FINAL DECISION
CitiPower distribution
determination
2016 to 2020

Attachment 6 – Capital
expenditure

May 2016

Figure 6.4 Capex per customer (000's, \$2013–14), against customer density

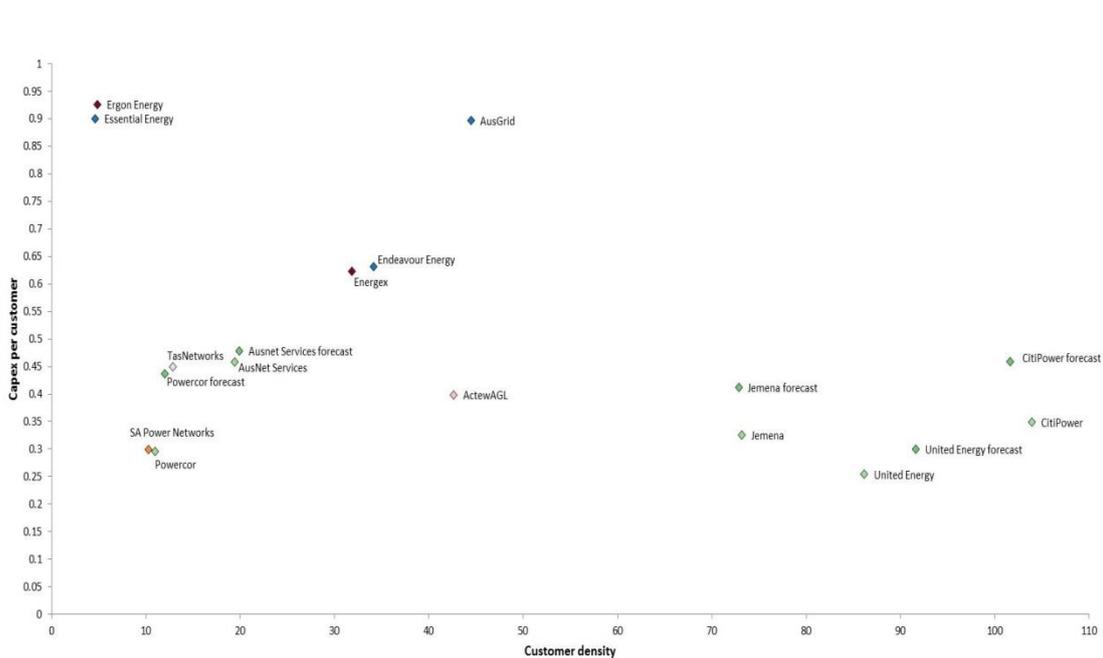
Figure 6.4 shows CitiPower is an outlier in that it has by far the highest customer density of the distributors in the NEM. In the 2008–12 years, it spent more capex per customer than Jemena and United Energy (the closest to CitiPower in terms of customer density). Further, CitiPower's capex per customer will increase in the 2016–20 period based on their revised proposal forecast capex. CitiPower's capex per customer will be relatively high in the 2016–20 regulatory control period even when taking customer density into account.

Figure 6.5 Capex per maximum demand (000's, \$2013–14), against customer density

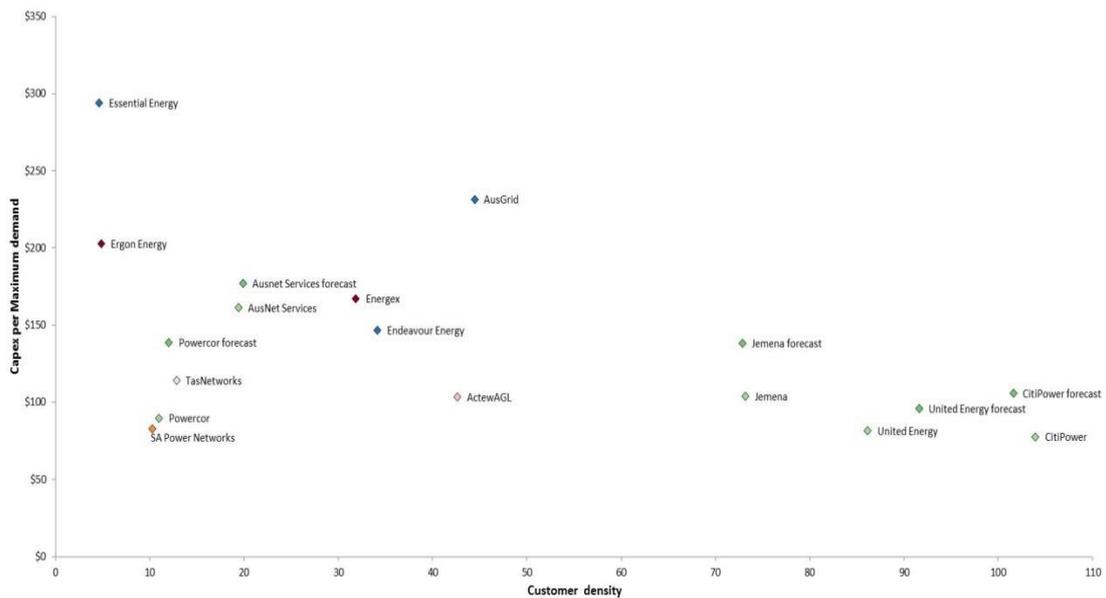
Figure 6.5 shows CitiPower spent less on capex per maximum demand in 2008–12 than Jemena and United Energy. Similar to Figure 6.4, capex per maximum demand will increase in the 2016–20 period based on their proposed forecast capex.

Figure 6.6 CitiPower total capex—historical and forecast for 2001–2020

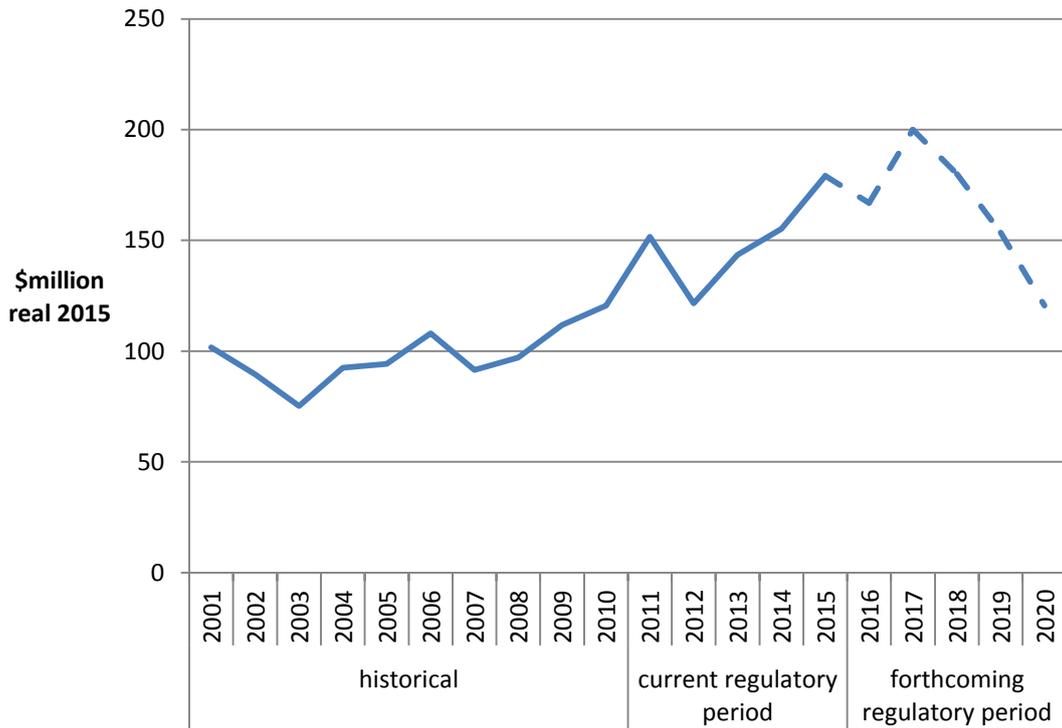
Figure 6.6 shows actual historical capex and proposed capex between 2001 and 2020. This figure shows that CitiPower's forecast is significantly higher than historical levels (actual spend), particularly for the first three years of the regulatory control period. CitiPower's capex forecast falls towards the end of the regulatory control period (to bring it back in line with the average levels of the 2011–15 regulatory control period).

Figure 6.7 CitiPower's demand-driven capex historic actual and proposed for 2016–20 period (\$2015, million, excluding overheads)

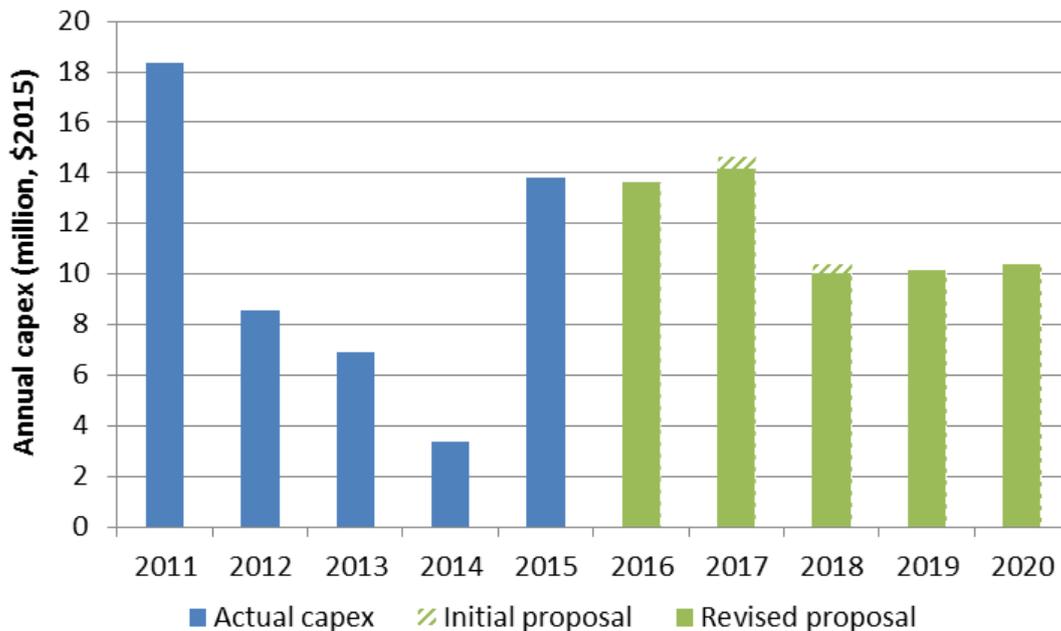
CitiPower's revised proposal included \$58.4 million in augex to respond to forecast maximum demand over the 2016–20 period. As shown in Figure 6.7, CitiPower has decreased its proposed demand-driven augex slightly from its initial regulatory proposal. CitiPower's revised proposal is 14 per cent higher than its actual demand-augex between 2011–15.

In turn, CitiPower has reduced its forecast demand-augex slightly (as shown in Figure 6.7). This reduction in demand augex in response to reduced and realistic maximum demand forecasts gives us some confidence in CitiPower's forecast capex. However, given the small decrease in demand augex, we have also looked at network utilisation to examine the impact of revised maximum demand forecasts on the need for network augmentation.⁶⁷

On the basis of our acceptance of CitiPower's revised maximum demand forecasts, and the stability of CitiPower's network utilisation forecasts, we accept that CitiPower's revised augex forecast is required to meet a realistic expectation of demand over the 2016-20 period. While CitiPower has not significantly reduced its augex forecast

Figure 6.8 CitiPower zone substation utilisation 2010 to 2020 (without augmentation)

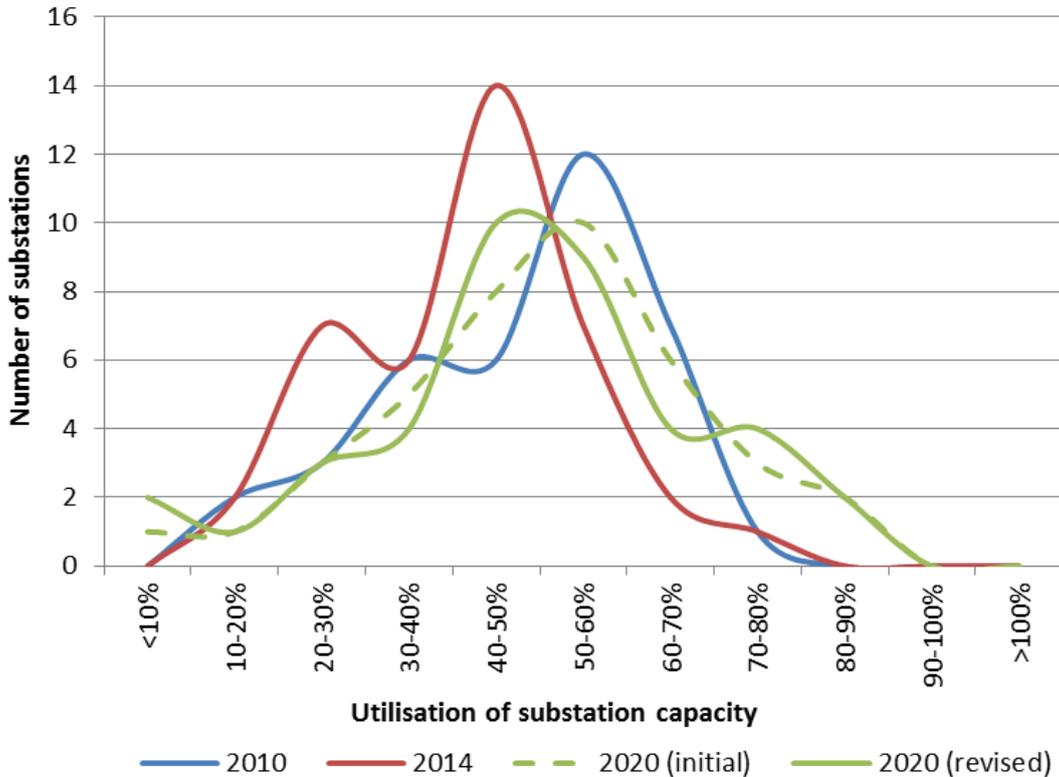
Figure 6.8 shows CitiPower's network utilisation (at the zone substation level) between 2010 and 2020. It shows that CitiPower experienced a decline in overall network utilisation between 2010 and 2014 due to augmentation and a flattening of demand (shown by a shift to the left in network utilisation by 2014). In contrast to the most recent years, CitiPower expected that network utilization will increase overall by 2020, with more zone substations forecast to operate above 60 per cent capacity and an increase in highly utilised zone substations.

As further shown in Figure 6.8, CitiPower's revised demand forecasts mean that the number of moderately utilised zone substations (e.g. between 40 and 60 per cent) declines (shown by the difference between the two green lines). However, the number of highly utilised zone substations has remained the same, if not increased. This indicates that capacity constraints remain on the network and have not changed significantly between the initial and revised maximum demand forecasts.

Figure 6.9 CitiPower - Actual and forecast repex (\$ million, 2015)

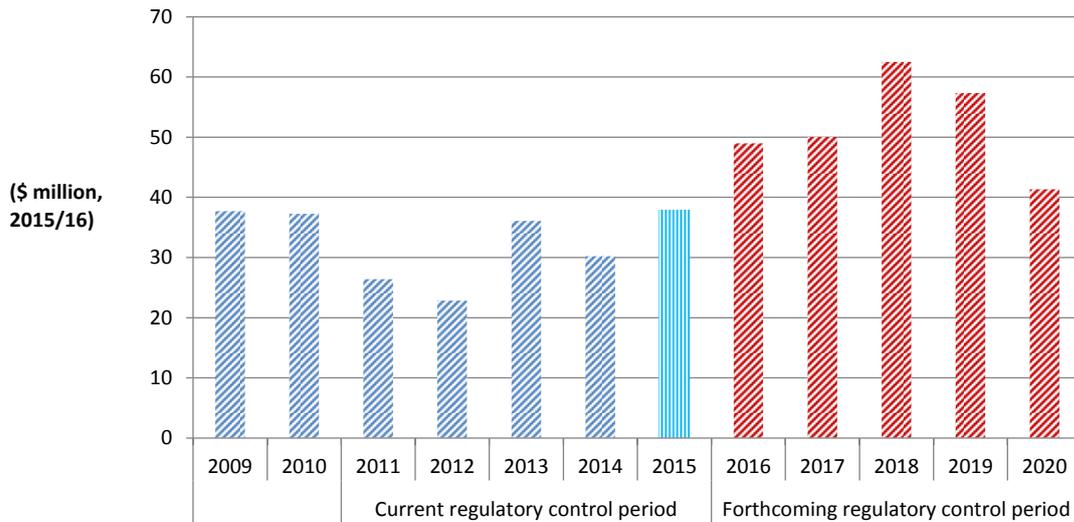
We have conducted a trend analysis of the proposed repex. The NER requires that we consider the actual and expected capital expenditure during any preceding regulatory control period.¹⁰⁶ Our use of trend analysis is to gauge how CitiPower's historical actual repex compares to its expected repex for the 2016–20 regulatory control period. Figure 6.9 shows CitiPower's repex spend has been variable across time, and is forecast to increase above historical levels for the 2016–20 regulatory control period.

satisfied that expenditure levels in the 2011–2015 years of Figure 6.9 can in part be attributed to the factors outlined above.

We are not satisfied that CitiPower's proposed repex of \$260 million, excluding overheads, reasonably reflects the capex criteria and therefore we do not accept CitiPower's proposed amount. We have instead included in our alternative estimate of overall total capex, an amount of \$235.5 million for repex, excluding overheads. This is 21 per cent lower than CitiPower's revised proposal. We are satisfied that this amount reasonably reflects the capex criteria.

Figure 6.10 Maximum system demand (Non-coincident, 10% PoE, MW)

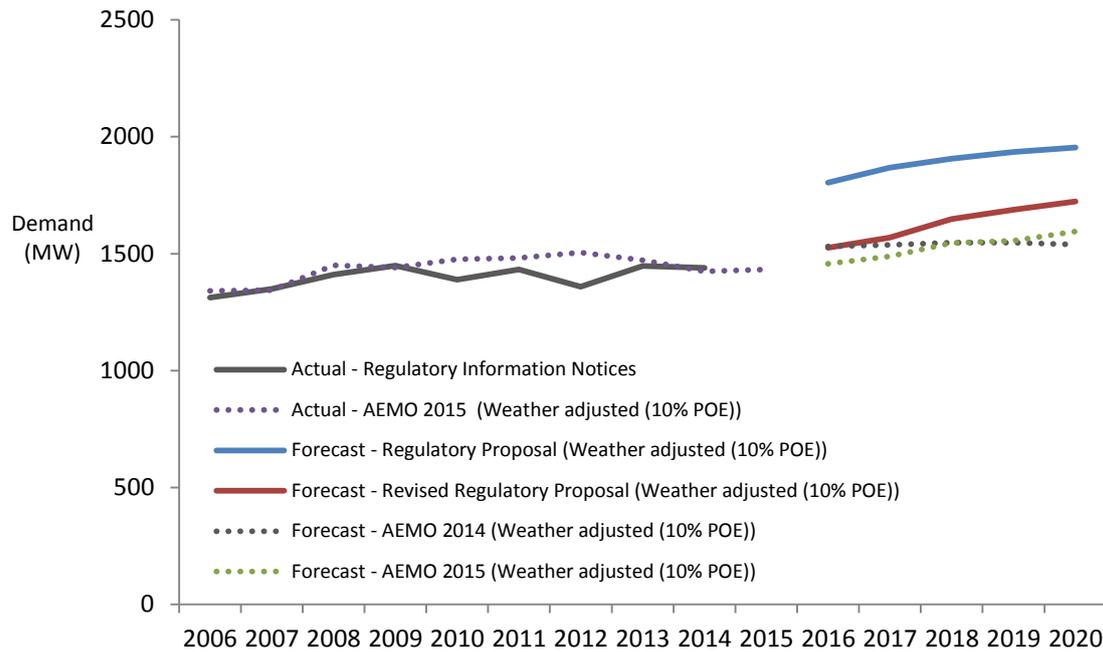
Figure 6.10 and Table 6.13 shows CitiPower's revised maximum demand forecast for the 2016–20 regulatory control period. CitiPower's revised forecast estimates slightly higher growth rate than the maximum demand between 2006 and 2015 (using weather adjusted historical demand). Figure 6.10 and Table 6.13 also provides AEMO's latest system demand forecast for its network (the 2015 connection point forecasts), which shows that CitiPower forecasts maximum demand to grow at a slightly faster rate than AEMO.

Using AEMO’s actual weather adjusted demand data for CitiPower, it can be seen that the actual underlying demand trend has grown slightly over the past 10 years and has flattened in recent years. This trend can be seen in Figure 6.10. CitiPower’s revised forecasts include some growth over 2016–20. As we set out in our preliminary decision, we consider that growth in rooftop solar and energy efficiency has contributed to reduced electricity drawn from the grid, and this may have dampened maximum demand growth on CitiPower’s network.
